SUBJECT: Addendum No. 1
Walker County Water & Sewerage Authority
McLemore Water Line Extension

ADDENDUM NO. 1

MCLEMORE WATER LINE EXTENSION

**WALKER COUNTY WATER & SEWERAGE AUTHORITY
FLINTSTONE, GEORGIA
CTI PROJECT NO. G21022**

McLEMORE WATER LINE	
DETAIL DA GRAVEL DRIVEWAY SECTION	
WCWSA	5/3/24

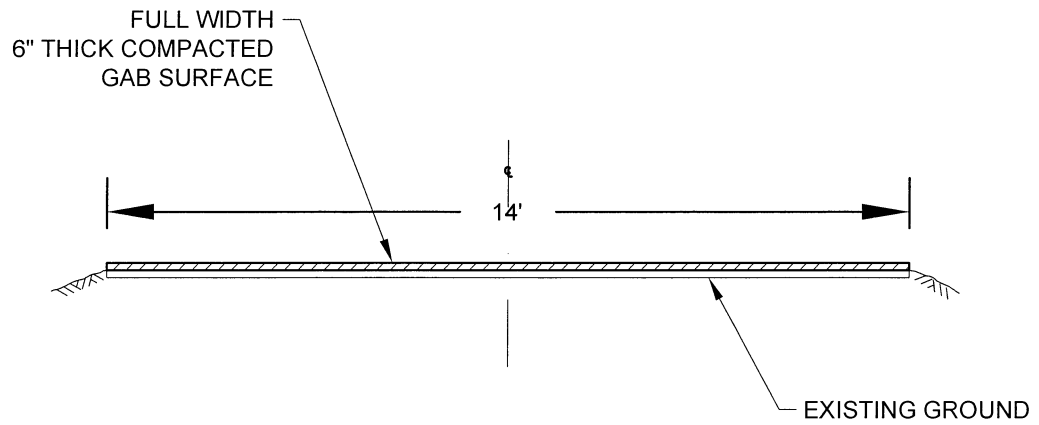
- I. **Drawing D102, Standard Details**, ADD the following attached details:
 - a. D102, Detail DA, Gravel Driveway Section
 - b. D102, Detail DB, Asphalt Driveway Section
 - c. D102, Detail DC, Concrete Driveway Section
